1 **B-29 Reliability Upgrades-Frequency Converter, \$1,320,200**

Engineering Condition Assessment
of the
Corner Brook Frequency Converter

Prepared by: Paul Nolan, P.Eng.
TRO Engineering Department
Newfoundland and Labrador Hydro
April 7, 2005

Figure 1 – 50 Hz Rotor (2005)

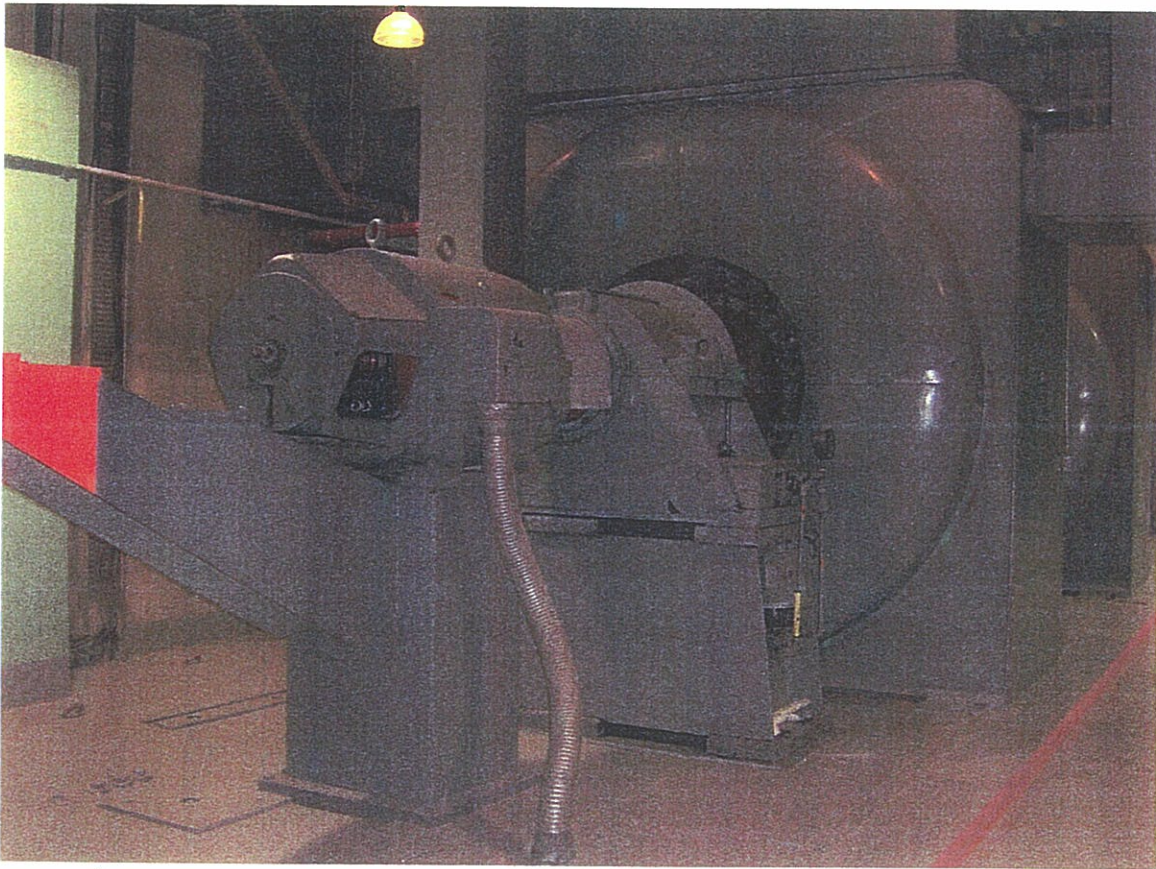
The insulation resistance value of the rotor windings is very low, in the order of 300 kohms. These low values are indicative of a failure within the next few years, but the failure could occur at any time. The rotors should therefore be rewound. Because the existing windings are asbestos insulated, the rewind will cost more than usual.

Readings of the insulation values of the 50 Hz rotor since 1998 remain very low (approximately 200 to 300 kohms.) The readings for the 60 Hz rotor, unlike the 50 Hz rotor, improved after cleaning.

- The condition of the insulation of the rotors (especially the 50 Hz rotor) was identified by Acres as very low. This issue has not been addressed. The 50 Hz rotor should be rewound as soon as possible. (A thorough assessment of the Grand Falls unit should be performed in order to explore the option of rewinding this unit as a replacement to the Corner Brook unit. This would decrease the length of the outage.) During this rewind, a thorough assessment of the other rotating equipment should be conducted.

Figure 3 – Top Half of the Pedestal Bearing (1998)

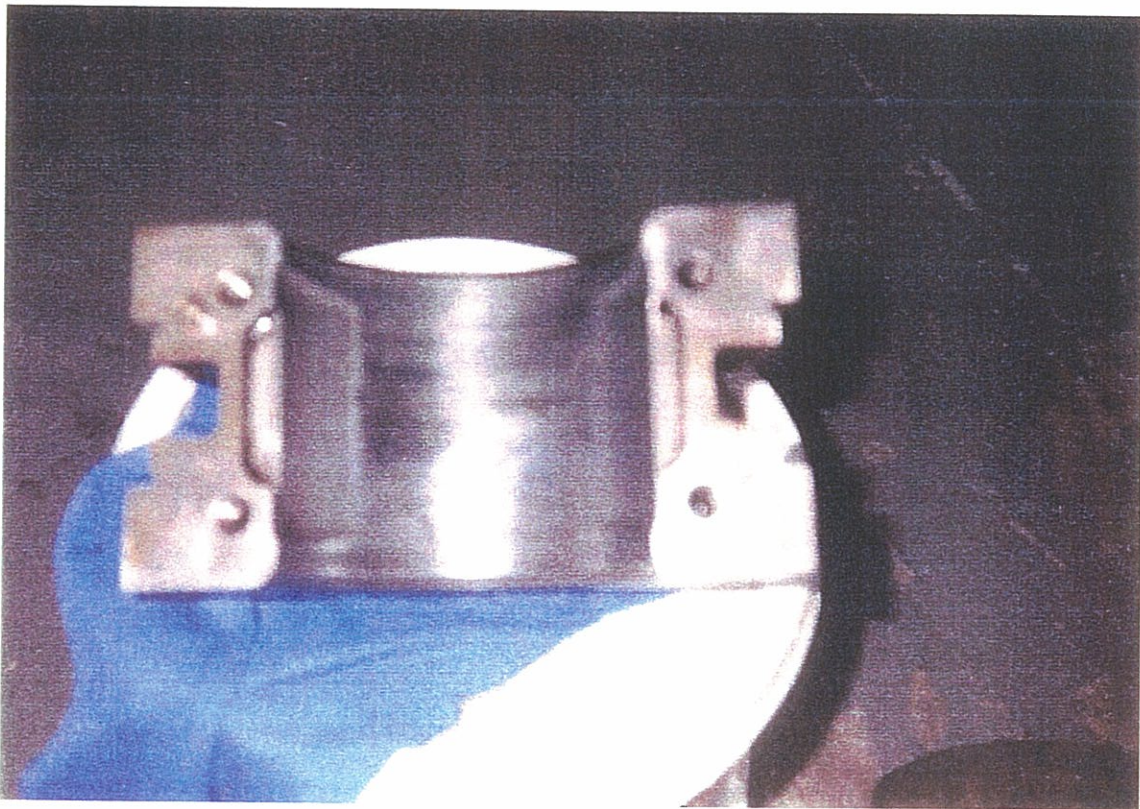
The pedestal bearing has been wiped and should be replaced.

It is incorrect to state that this bearing has been wiped. This bearing has been partially wiped. A wiped bearing would likely cause damage due to contact between the shaft and the bearing shell. A machine cannot be operated with a wiped bearing.

The bearing should be replaced as soon as possible. It is running at higher than normal temperatures, as evidenced by the condition of the oil, and bearing failure is possible. This could cause shaft damage and a lengthy outage.

Figure 5 – Example of Crack in Wall (2005)

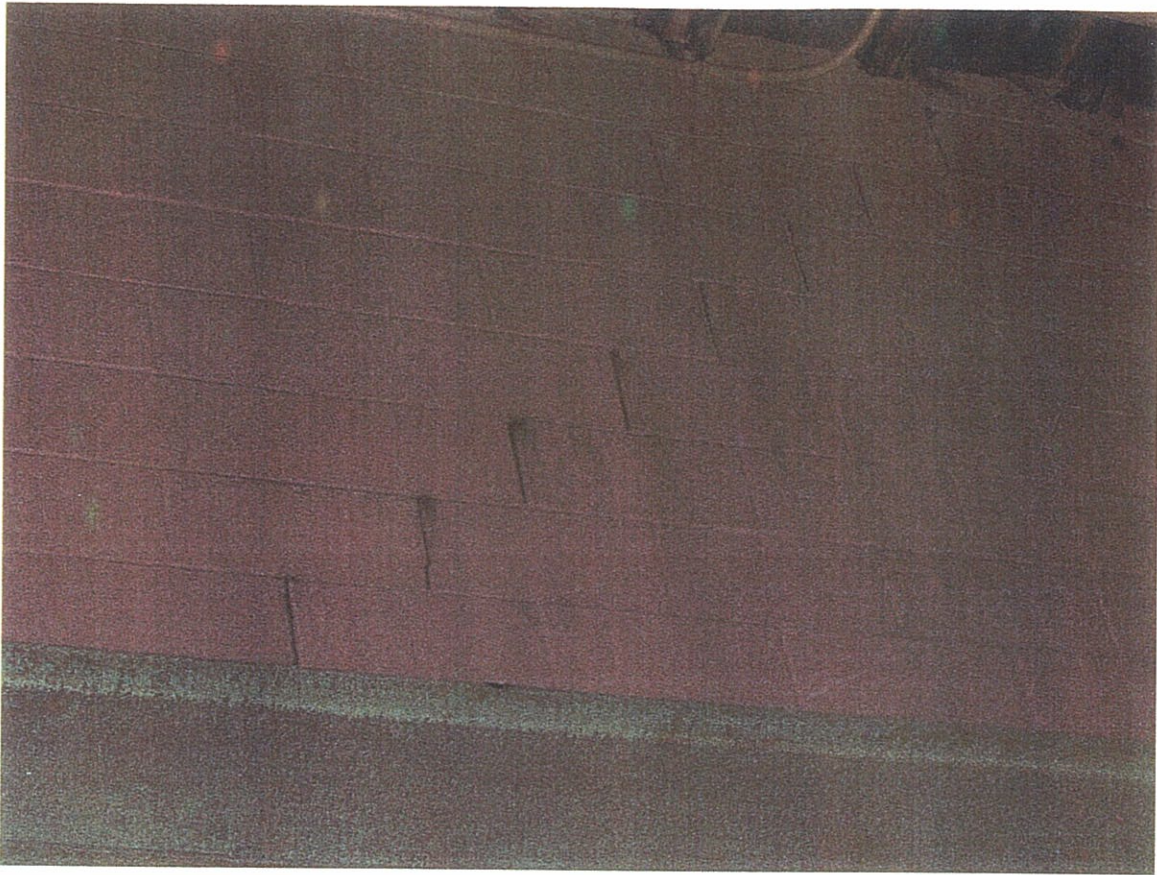
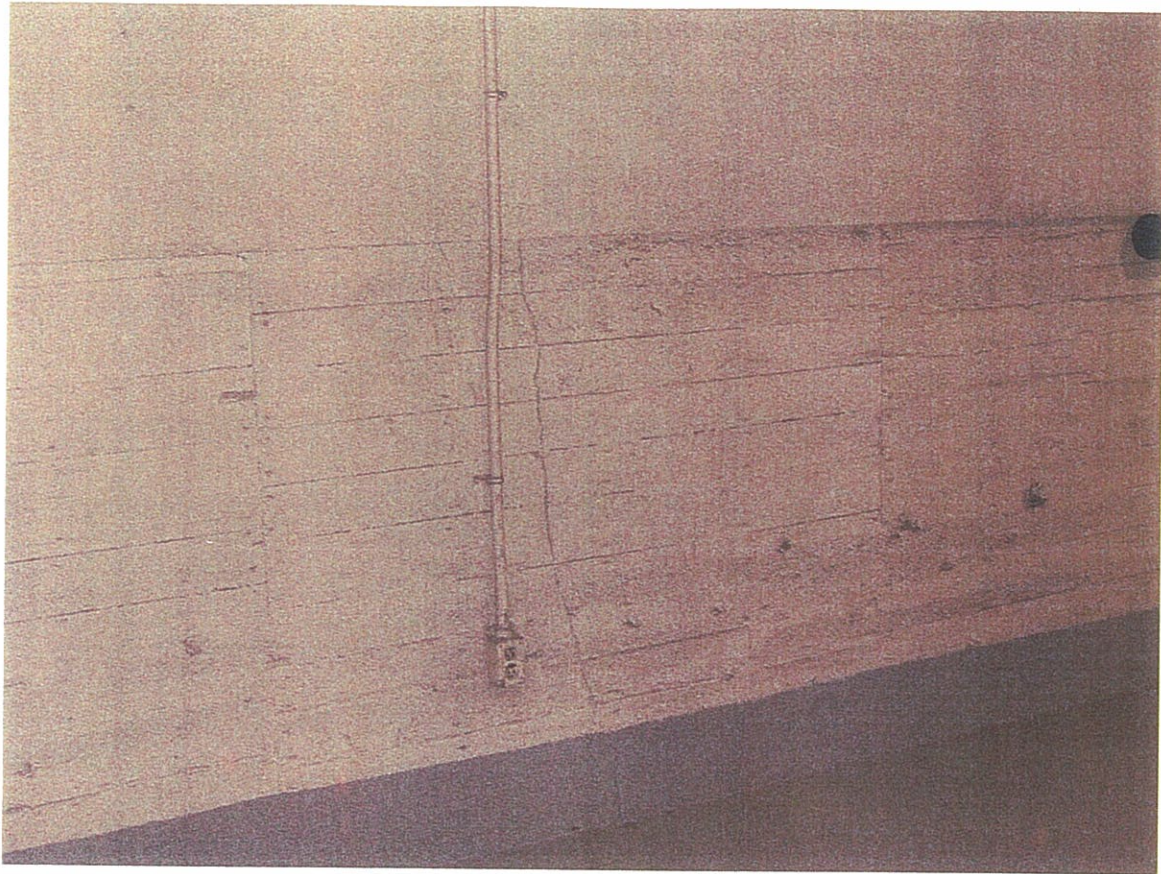
The building requires repair. Concrete and bricks have fallen from the roof and building sides and damaged the bushings and post insulators. Building cracks have allowed entrance of the wood debris associated with operation of the paper mill. The ceiling in the stairwell is temporarily repaired using a sheet of plywood. This should be permanently repaired.

Repairs have been made to the roof and stairwell ceiling. Caulking has been applied to building cracks when possible to decrease the ingress of dirt and dust. The overall condition of the building remains poor.

Repairs to the concrete and masonry (\$5,000 estimate) should be done as soon as possible.

Figure 11 – Liquid Rheostat (2005)

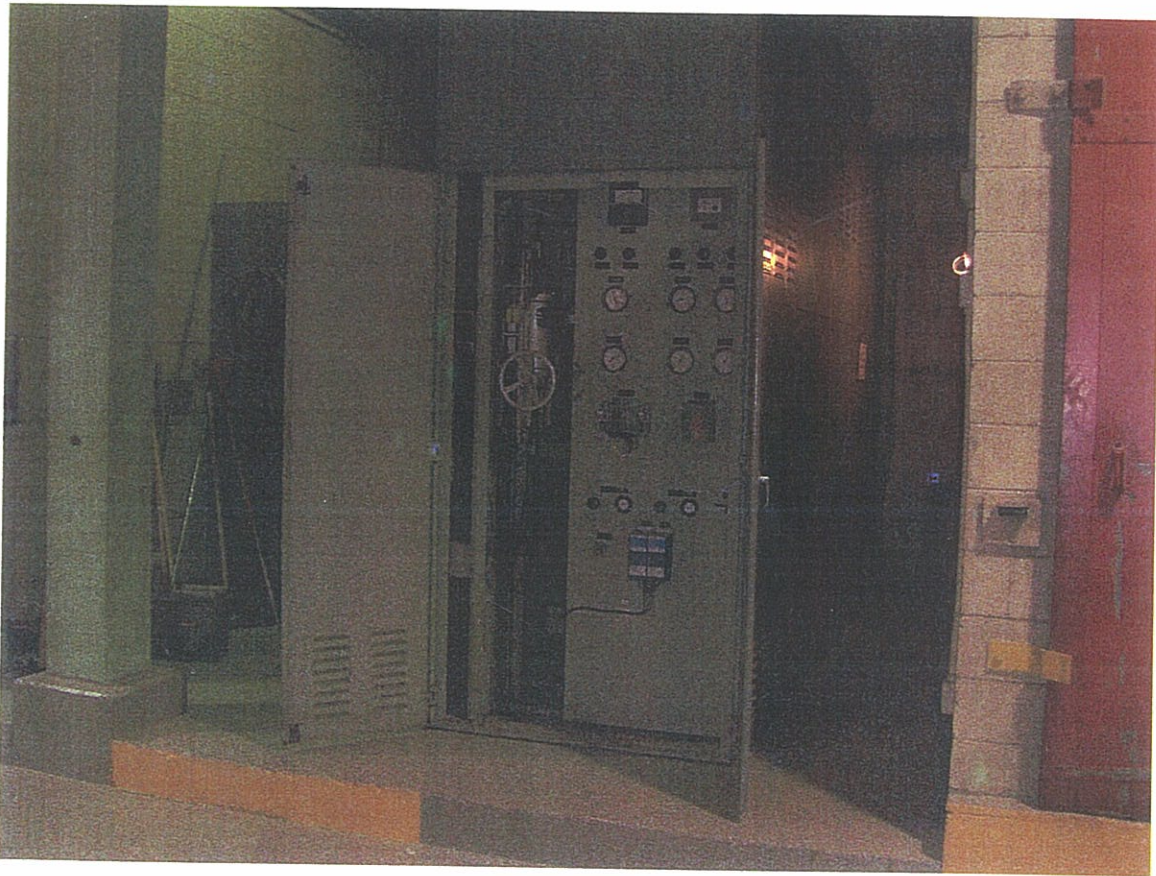
The building and piping asbestos insulation has been removed. The chamber of the liquid rheostat is asbestos lined and is still in service.

This site has been identified under Hydro's Asbestos Abatement Program and is scheduled to be inspected this summer. The results of the inspection will determine the course of action required by Hydro.

Protective Structure for T2 External 66 kv Bus, steel frame and wire mesh removed.

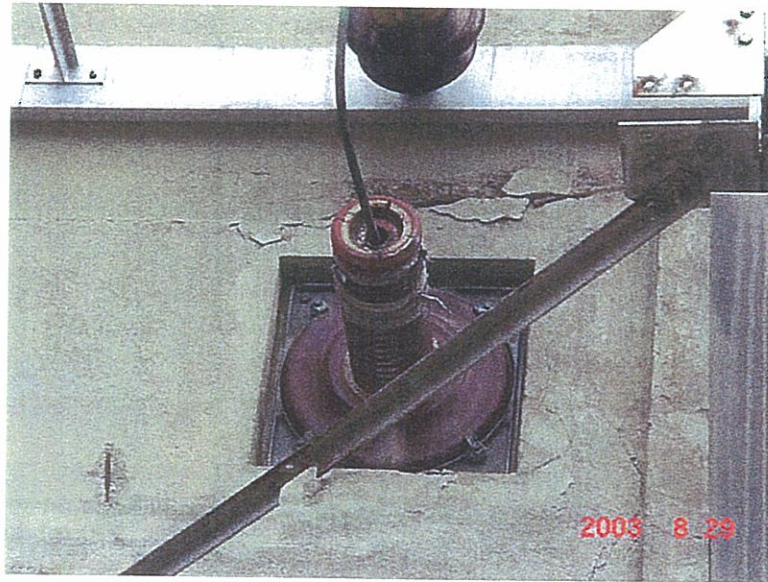
Last year, in order to facilitate the removal of T2 from the Frequency Converter Building, part of the protective structure that prevents the incidental contact between the 66 kv Bus and Mill Personnel/Equipment was removed. For safety reasons it is recommended that this structure be reinstated to its original condition as soon as possible. See drawing No. 401-S-16-Rev. 2.

Damaged C phase entrance insulator.

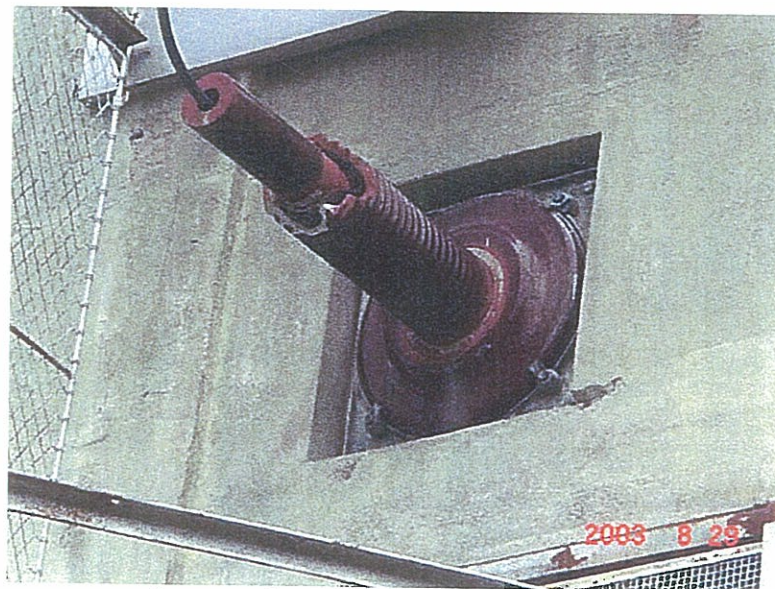
Both A and C phase entrance insulators for the 500 MCM Conductor leading to T2 have sustained considerable physical damage, resulting in reduced leakage distances and an increased probability of flashover. It is recommended that both A and C phase insulators be replaced as soon as a suitable substitute can be found. The existing insulators are vintage 1966, Canadian Porcelain, 69 kv, 350 BIL, catalogue No. 1216. Dave Hicks of TRO Engineering has been contacted for assistance in locating the replacement insulator.

C.O.B. pincap insulators, 66 kv Bus CBPPL frequency converter building.

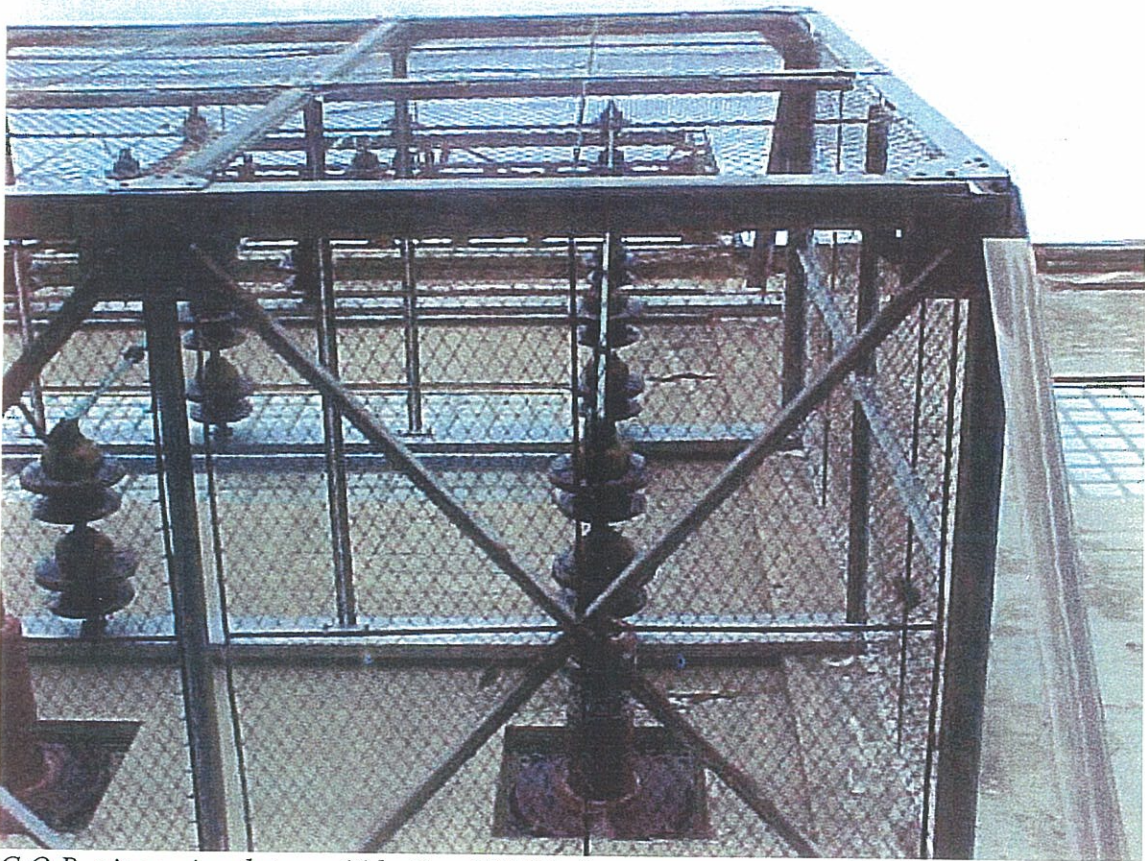
The current 66 kv Bus arrangement on the frequency converter building is supported by C.O.B. pincap and suspension insulators. These types and make of insulators have been failing at an ever increasing rate in many of our terminal stations, distribution, and transmission lines. Therefore, it would be prudent to consider changing out these insulators within the next several years. The pincap insulators are vintage 1966, C.O.B., catalogue No. 37769 (double units), 36 units would require replacement. The suspension insulators are vintage 1966, C.O.B., ball and socket type, catalogue No. 32436. 12 strings of 5 units would require replacement. Hydro currently stocks suitable station post and suspension type insulators for this work.
